# Zoning Text Amendment Report PLNCOM24-0048

## **Subdivision Regulations Text Amendment**

To amend the Minimum Subdivision Regulations by adding a new street cross section alternative for fire apparatus access.

## **Proposed Fire Apparatus Access Road**

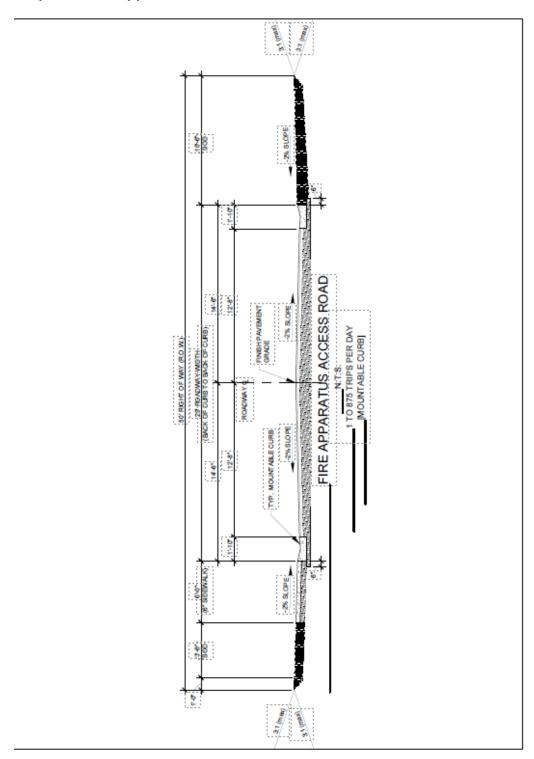
The new section would accommodate up to 875 trips per day and has been approved by the KFD as an acceptable design for dead end streets. The focus of the new cross section proposal is to maintain a hard surface path and wider right-of-way to properly accommodate fire apparatus. This is accomplished by promoting the key standards below when compared to a residential lane:

Right-of-way width minimum: 50'

Hard surface width (street and mountable curb and sidewalk): 35'

Maximum Trips: 1 to 875
